FINAL ENVIRONMENTAL IMPACT REPORT

SHERMAN OAKS - STUDIO CITY - TOLUCA LAKE - CAHUENGA PASS COMMUNITY PLAN AREA

*Harvard-Westlake School
Parking, Safety and Athletic Improvement Plan
Case Number: ENV 2013-0150-EIR
State Clearinghouse No. 2013041033*

Figure 2-2
Harvard-Westlake Upper School Campus Plan

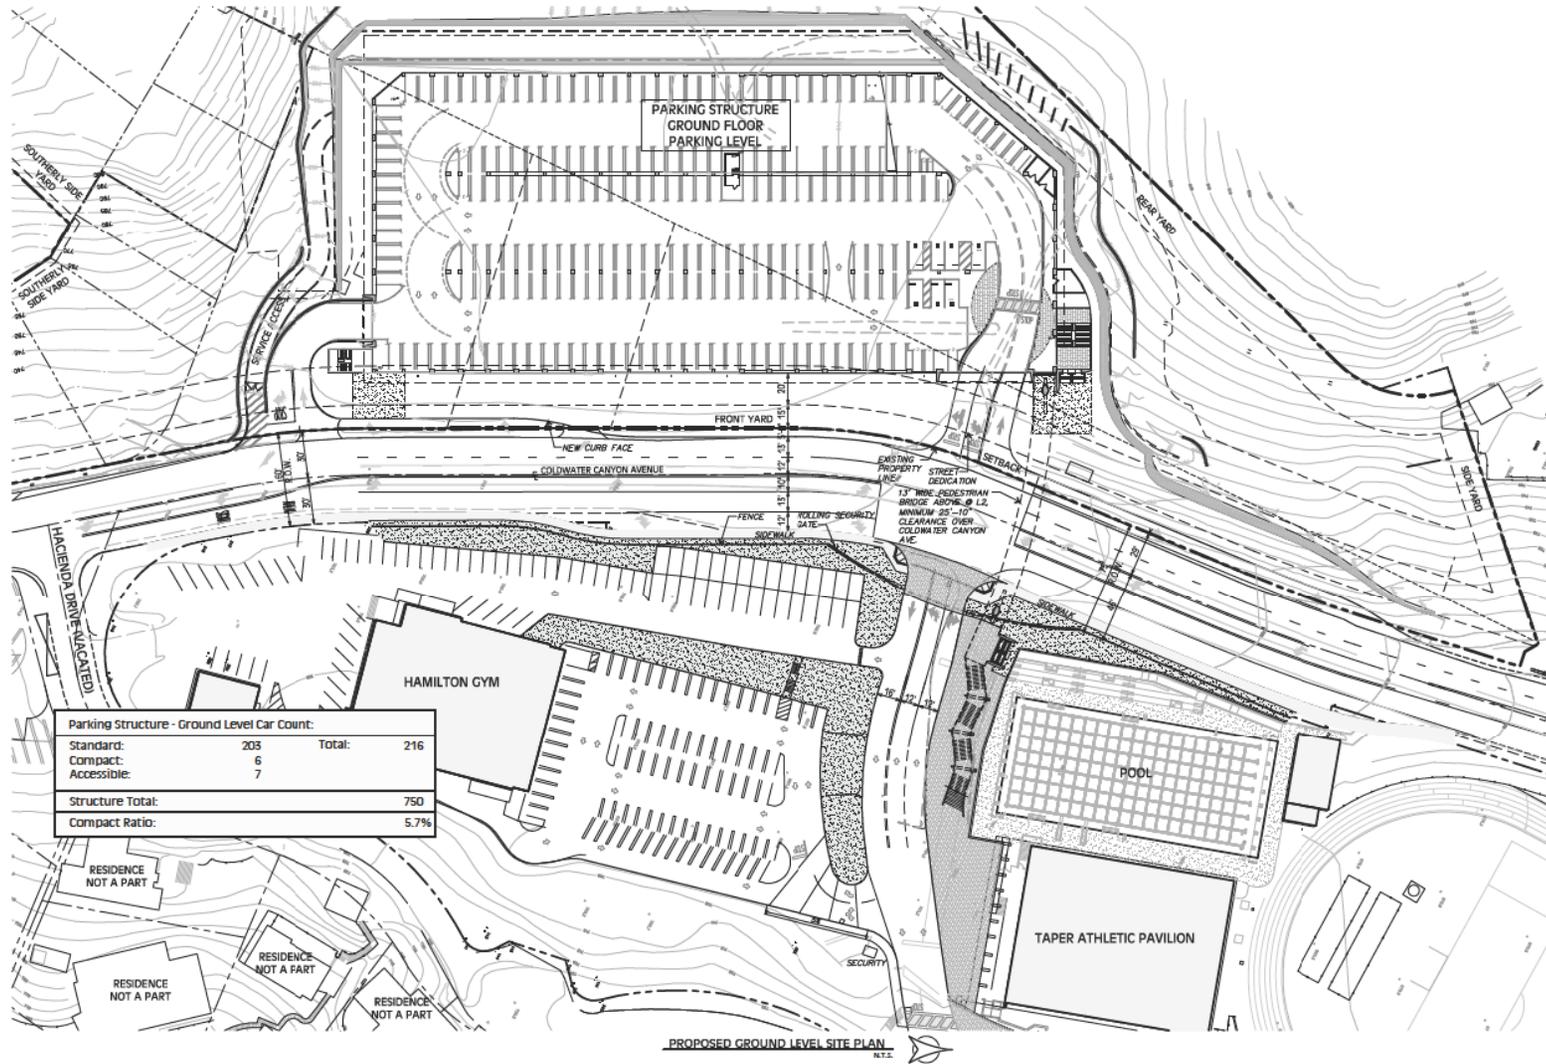
Page 2-4, Figure 2-2 is revised to show removal of the house on Potosi Avenue; see following.

Rendering of Parking Structure and Pedestrian Bridge Looking South (Aerial View) Along Coldwater Canyon Avenue

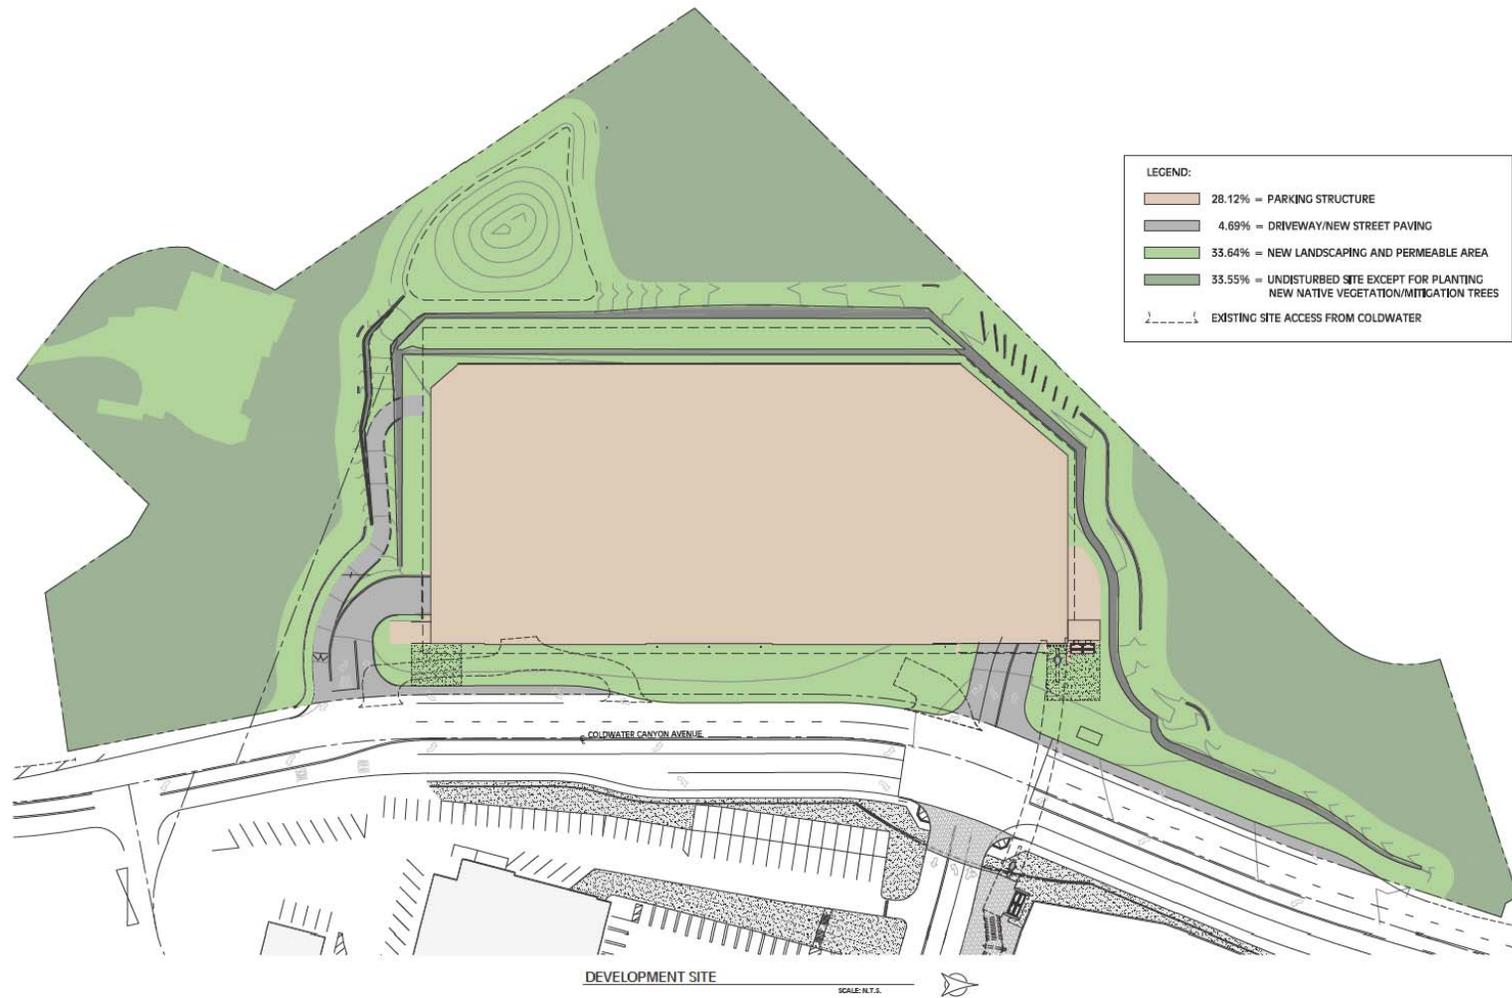
Page 2-33, Figure 2-11 is revised to show removal of the house on Potosi Avenue; see following.

Development Site -- Structure, Pavement and Landscaping

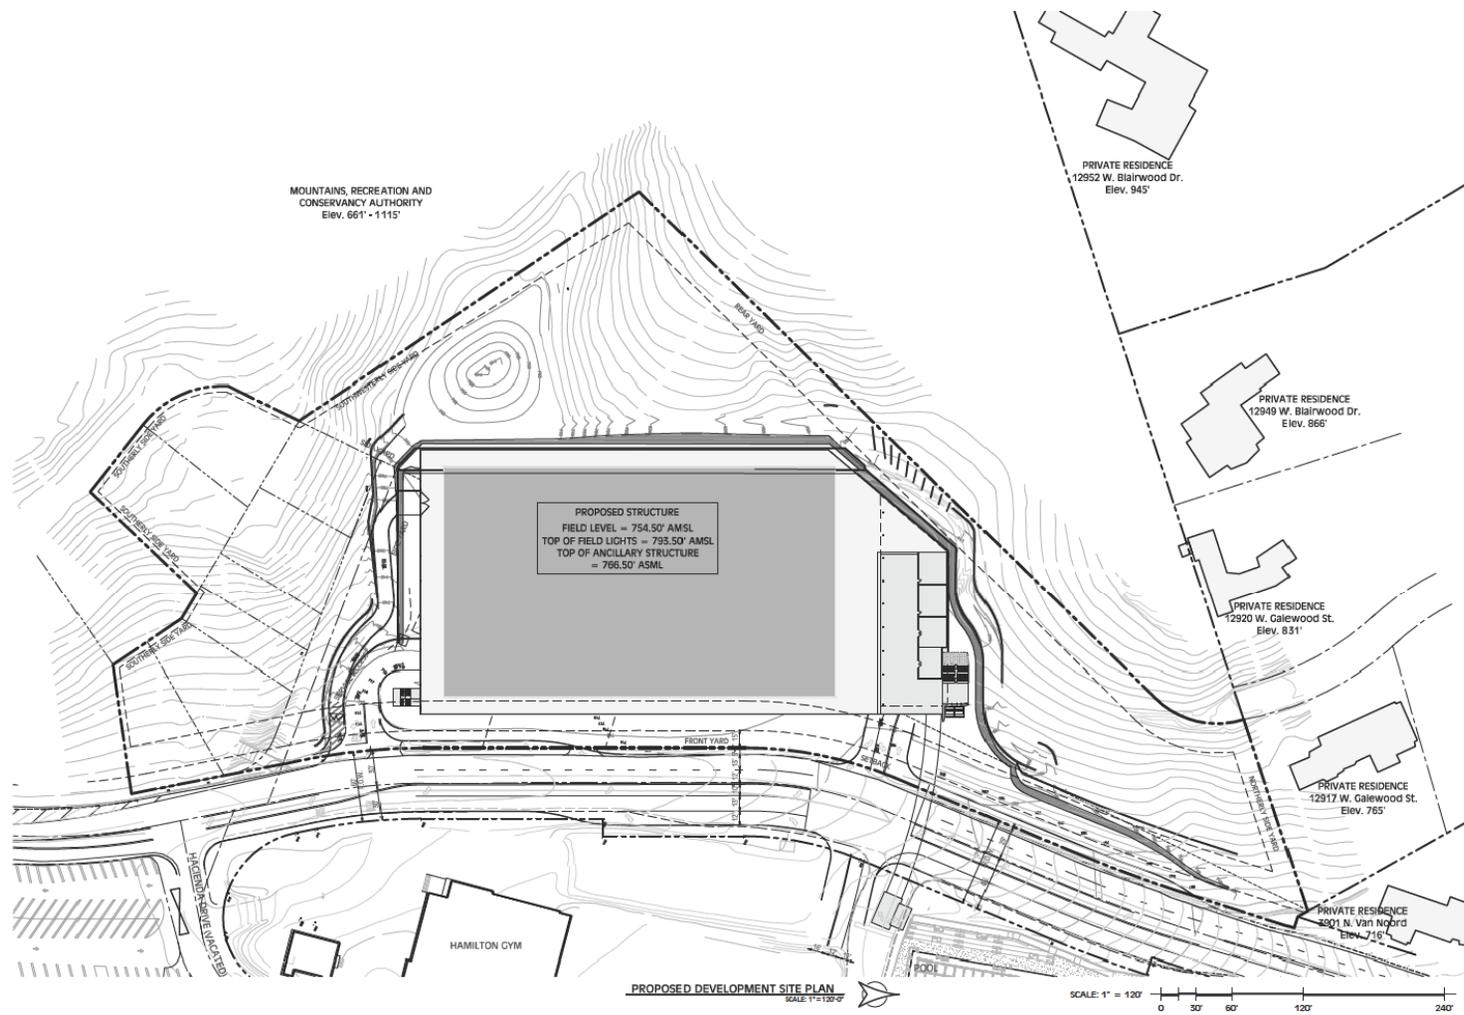
Page 3.1-26, Figure 3.1-26 is revised to show the new construction limit line as a result of removing the house on Potosi Avenue; see following.

Figure 3.1-30
Lighting Map

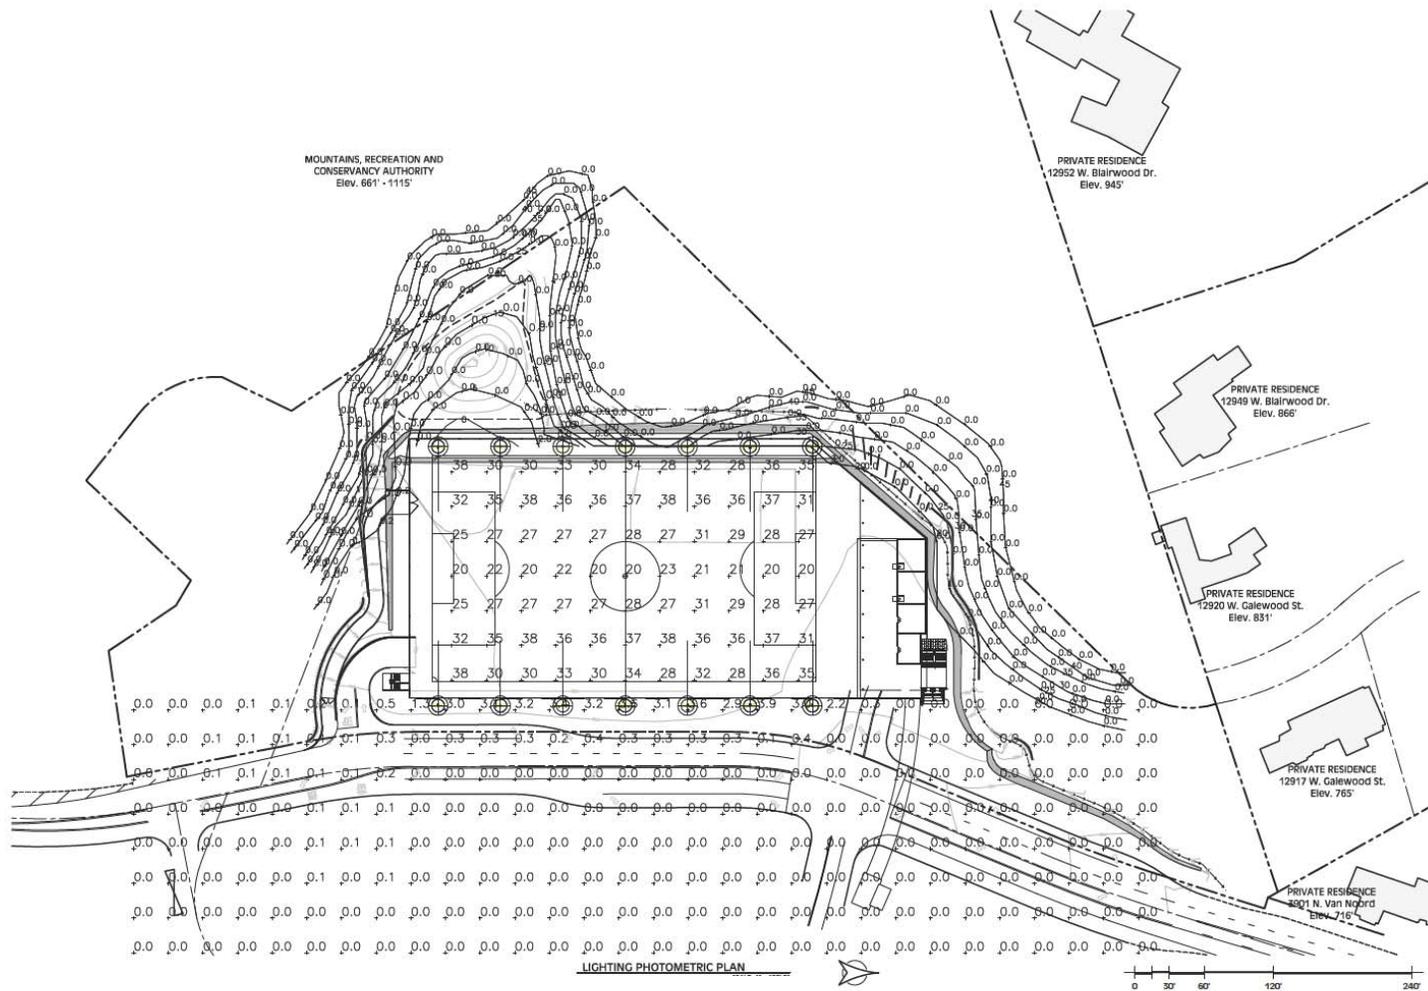
Page 3.1-37, Figure 3.1-30 is revised to show removal of the house on Potosi Avenue; see following.

Figure 3.2-2

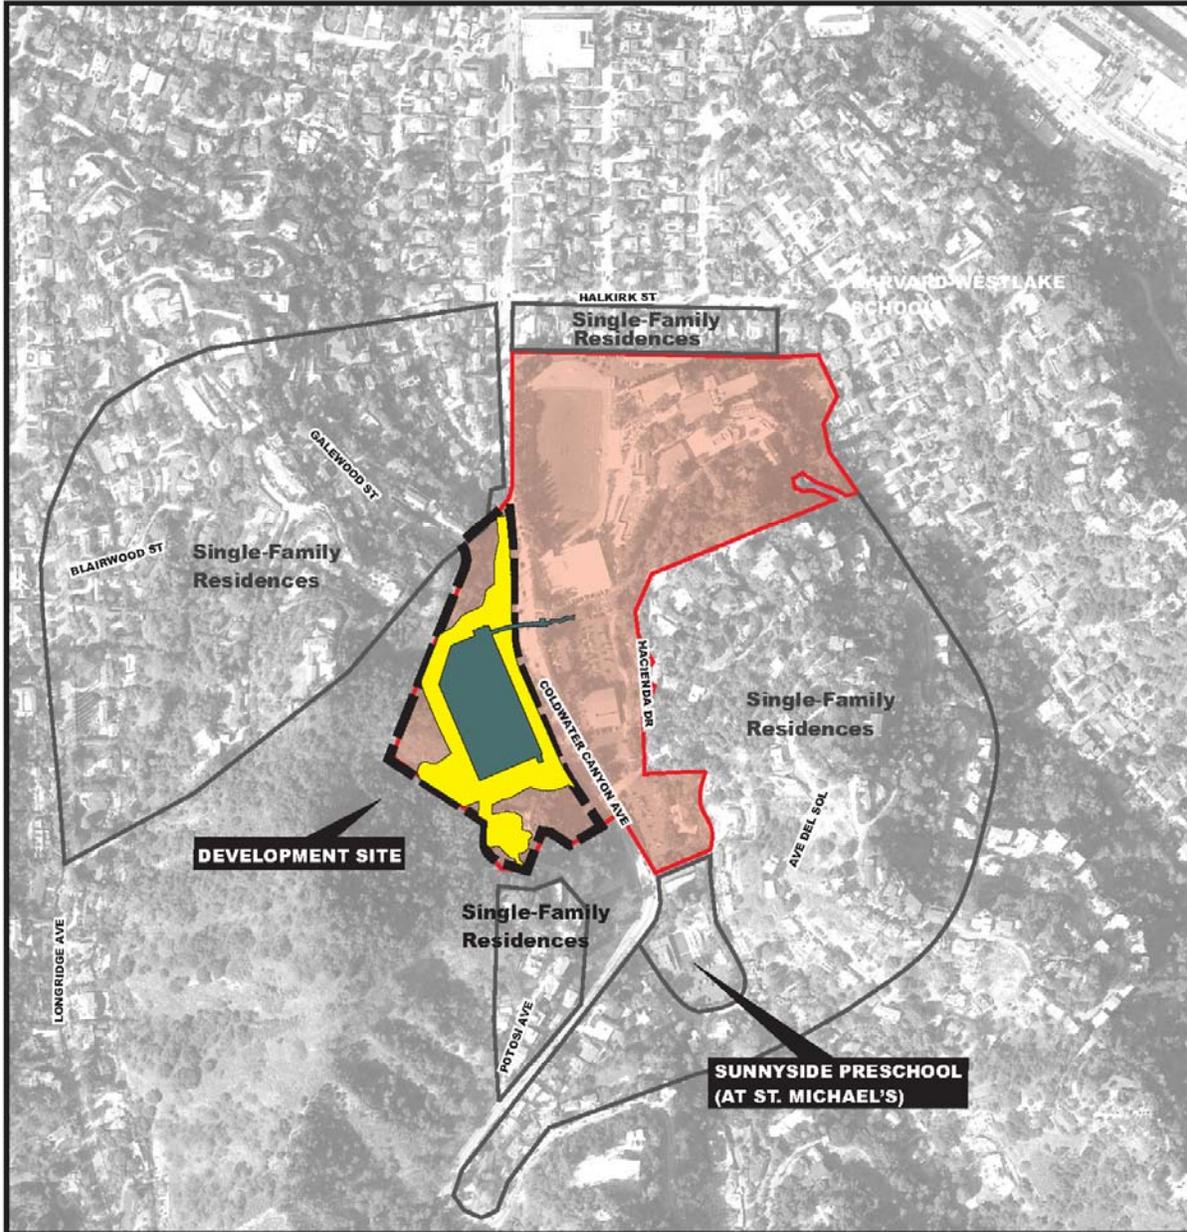
Page 3.2-12, Figure 3.2-2 is revised to show the revised construction limits, to show the removal of the house on Potosi Avenue.

Figure 3.2-4
Construction Schedule

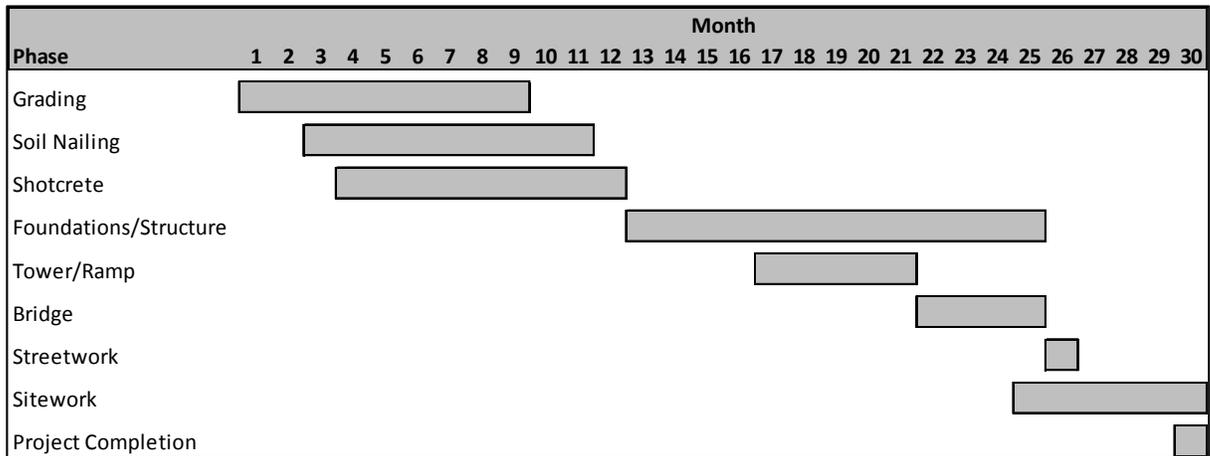
Page 3.2-26, Figure 3.2-4 (Construction Schedule) is added as follows:

Figure 3.3-2
Vegetation Impact Map

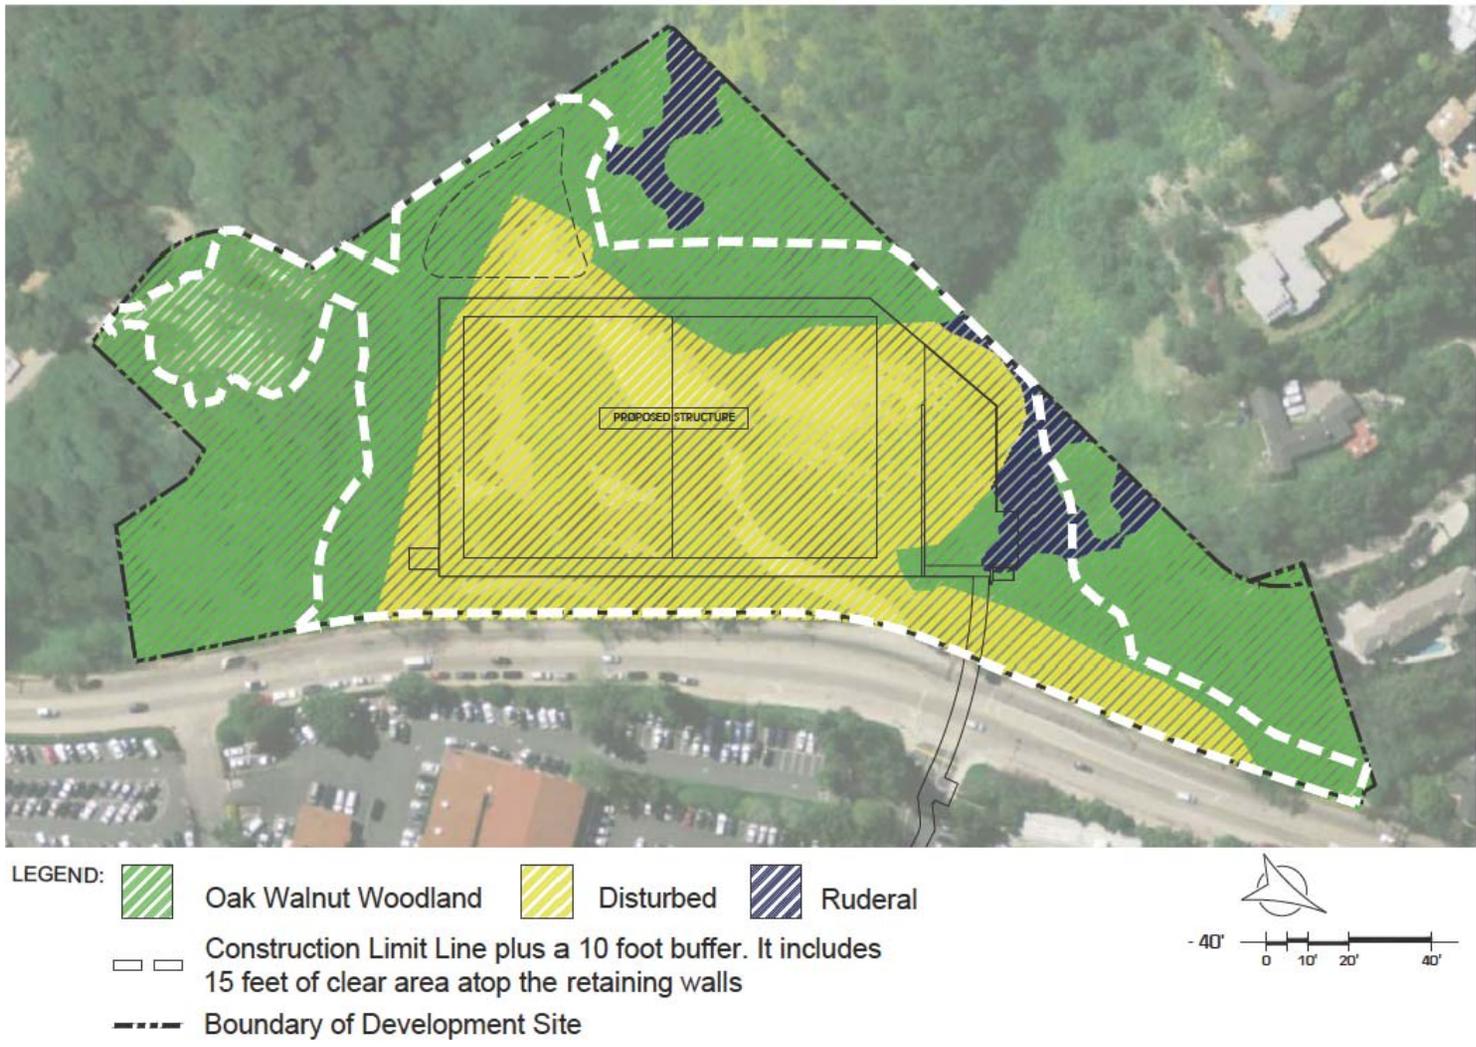
Page 3.3-18, Figure 3.3-2 is revised to show the revised construction limit line with the removal of the house on Potosi Avenue.

Harvard-Westlake Parking Structure ■
Figure 3.5-3
 Depth of Excavation

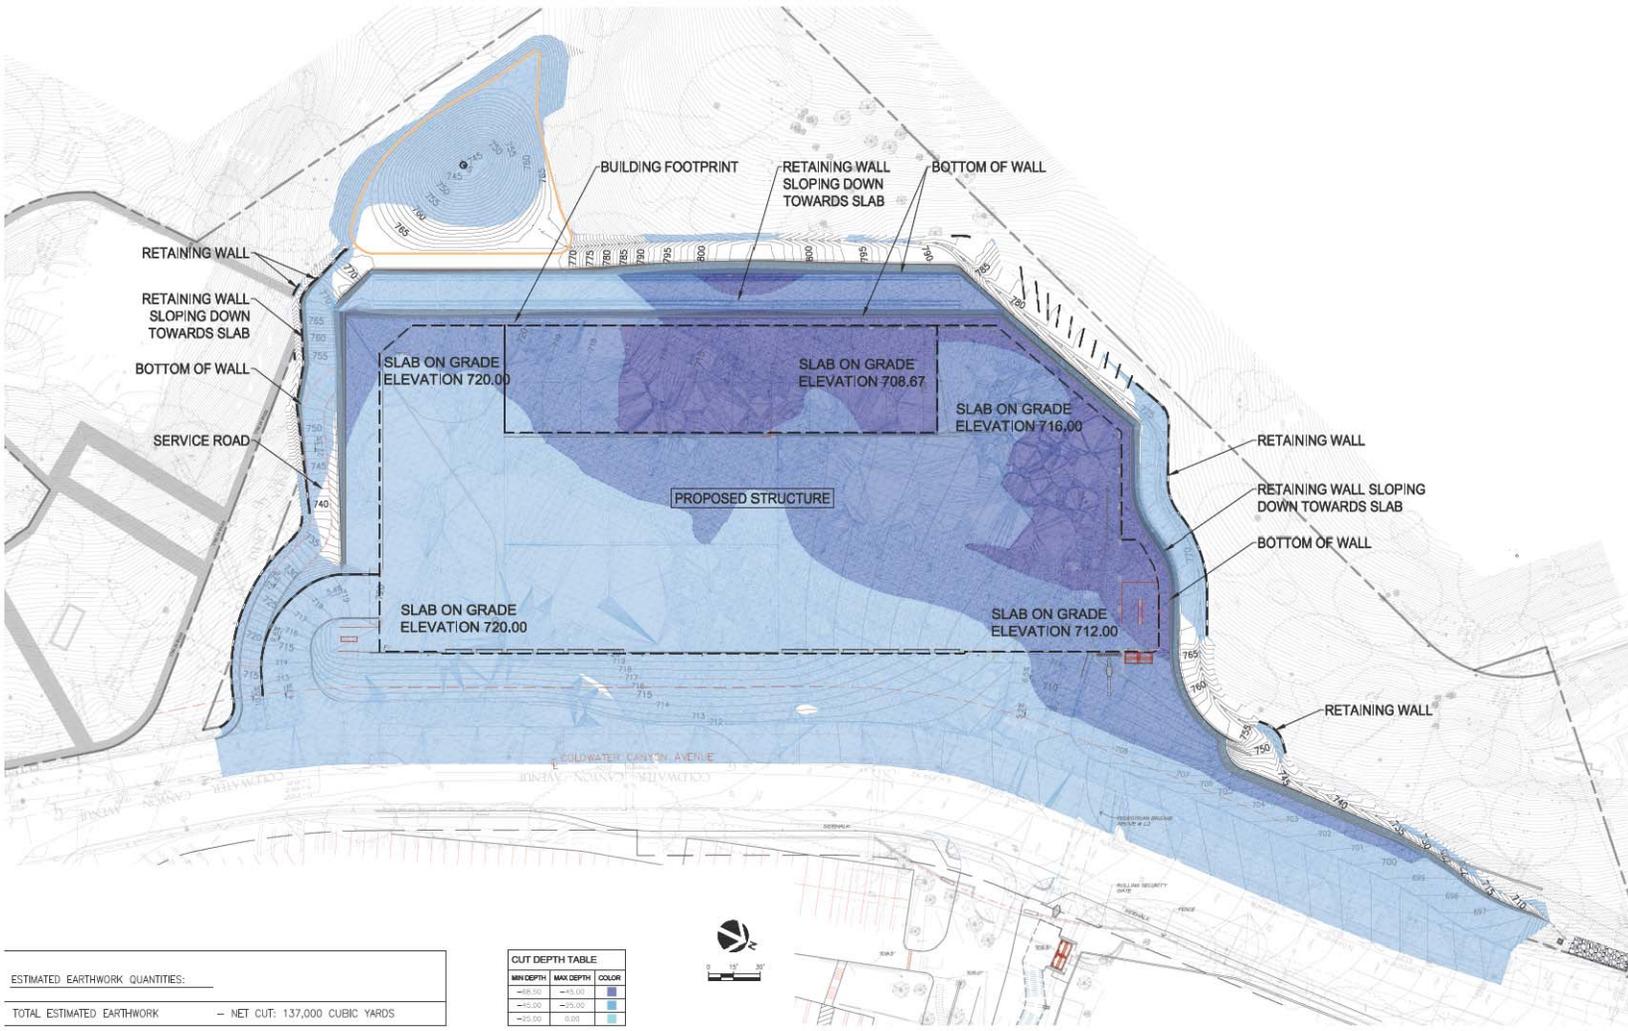
Page 3.5-24, Figure 3.5-3 is revised to show removal of the house on Potosi Avenue; see following.
